DART AEROSPACE LTD	Work Order: 102958	JW 102957
Description: Crosstube High Fwd (205/212/412)	Part Number: D212-664-101	
Inspection Dwg: D212-664-141 Rev: D	Page 1 of 1

DRAWING NO. D212-664-141	TITLE XTUBE ASSY (205/212/412 HI FWD)	REV. D	DART AEROSPACE LTD ENGINEERING ORDER		D.E.O. NO. D212-664-141-D-1	SHEET NO SHEET 1 OF 2	SCALE NTS
DRAWN	CHECKED	MP	MFG. APPR.	RE	APPROVED	NA	DE APPR
DATE 11.04.07	DATE 11.07.11		DATE 11.04.12		DATE 11/04/12		DATE 11.04.12

ADD AN INSPECTION WINDOW TO UNDERSIDE OF CROSSTUBE.

**D212-664-141-141B
ASSEMBLY DETAIL**

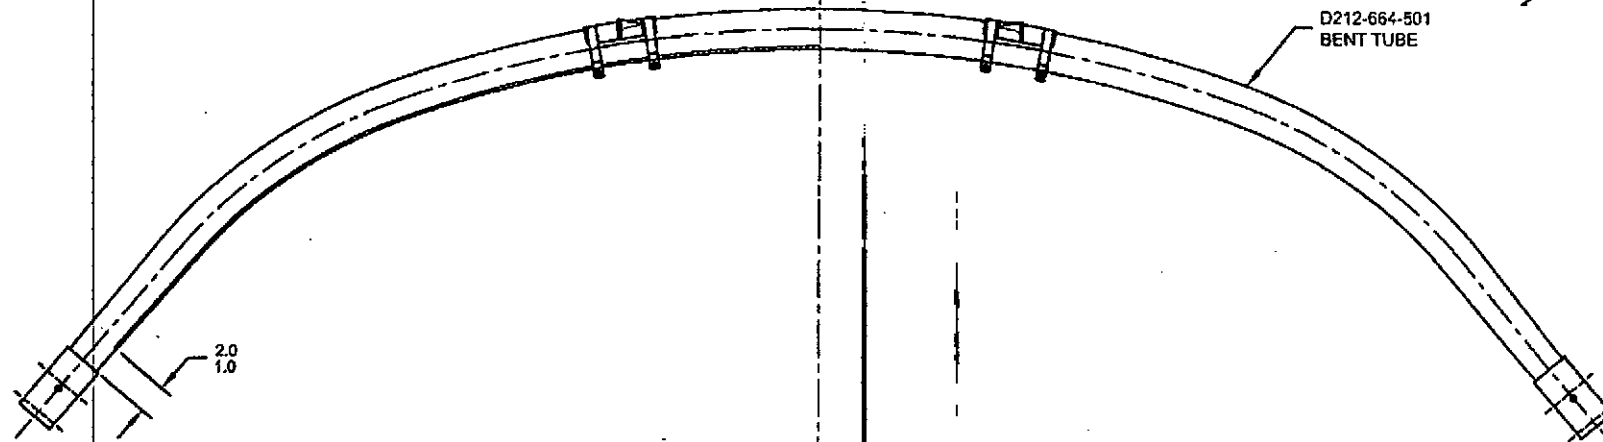
- 2) FINISH: CHEMICAL CONVERSION COAT PER DART QSI 005 4.1
PRIME INSIDE AND OUTSIDE PER DART QSI 005 4.2
MASK UNDERSIDE OF CROSSTUBE AS SHOWN (HATCHED AREA) AND
PAINT OUTSIDE PER DART QSI 005 4.2
REMOVE MASKING AND APPLY CLEAR COAT

- 2) FINISH: CHEMICAL CONVERSION COAT PER DART QSI 005 4.1
PRIME INSIDE AND OUTSIDE PER DART QSI 005 4.2
PAINT OUTSIDE PER DART QSI 005 4.2

MASK AREA PRIOR TO PAINTING.
REMOVE MASKING AFTER PAINT
AND APPLY CLEAR COAT

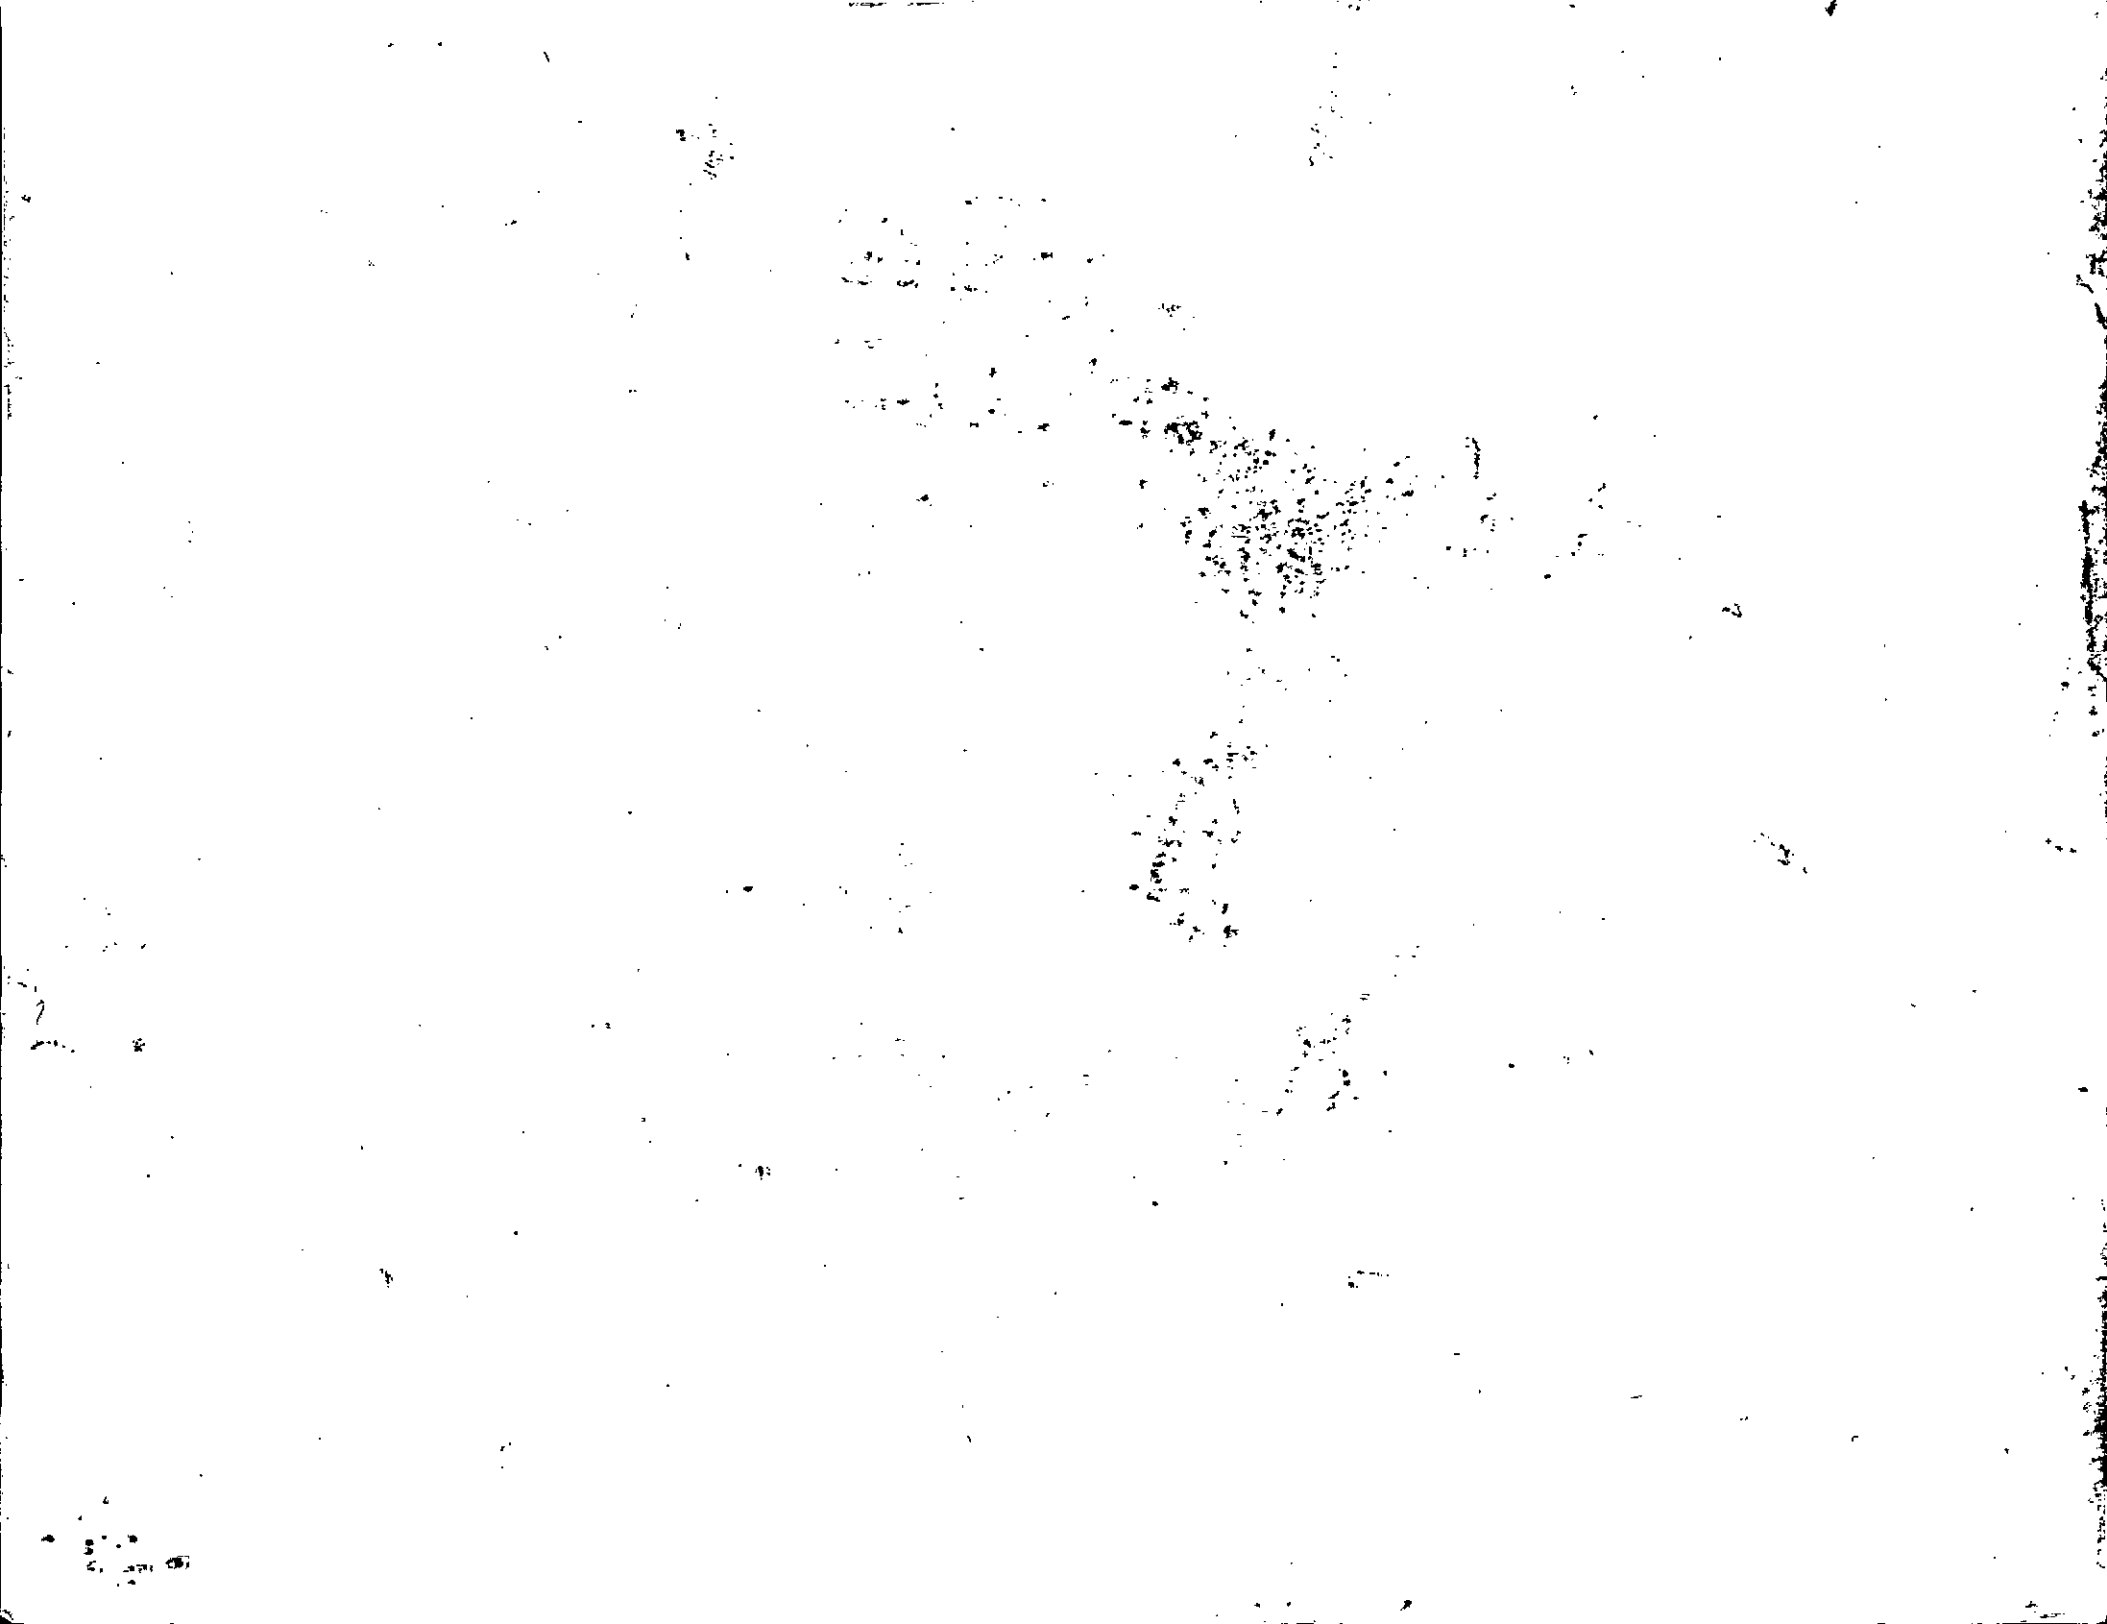
ADD NEW CONFIGURATION WITH ANODIZED FINISH

ADD -141F CONFIGURATION TO PARTS LIST AS SHOWN BELOW:

AMEND NOTE 2 AS FOLLOWS:

- 2) FINISH -141 & -141B ONLY: a) CHEMICAL CONVERSION COAT PER DART QSI 005 4.1
b) PRIME INSIDE AND OUTSIDE PER DART QSI 005 4.2
c) MASK UNDERSIDE OF CROSSTUBE AS SHOWN IN DEO D212-664-141-D-1
d) PAINT OUTSIDE PER DART QSI 005 4.2
e) REMOVE MASKING AND APPLY MATTE CLEAR COAT

- FINISH -141F: a) ANODIZE PER MIL-A-8625, TYPE II, CLASS 1
b) ALODINE (DO NOT ETCH) PER QSI 005 4.1.2
c) PRIME INSIDE AND OUTSIDE PER DART QSI 005 4.2
d) MASK UNDERSIDE OF CROSSTUBE AS SHOWN IN DEO D212-664-141-D-1
e) PAINT OUTSIDE PER DART QSI 005 4.2
f) REMOVE MASKING AND APPLY MATTE CLEAR COAT
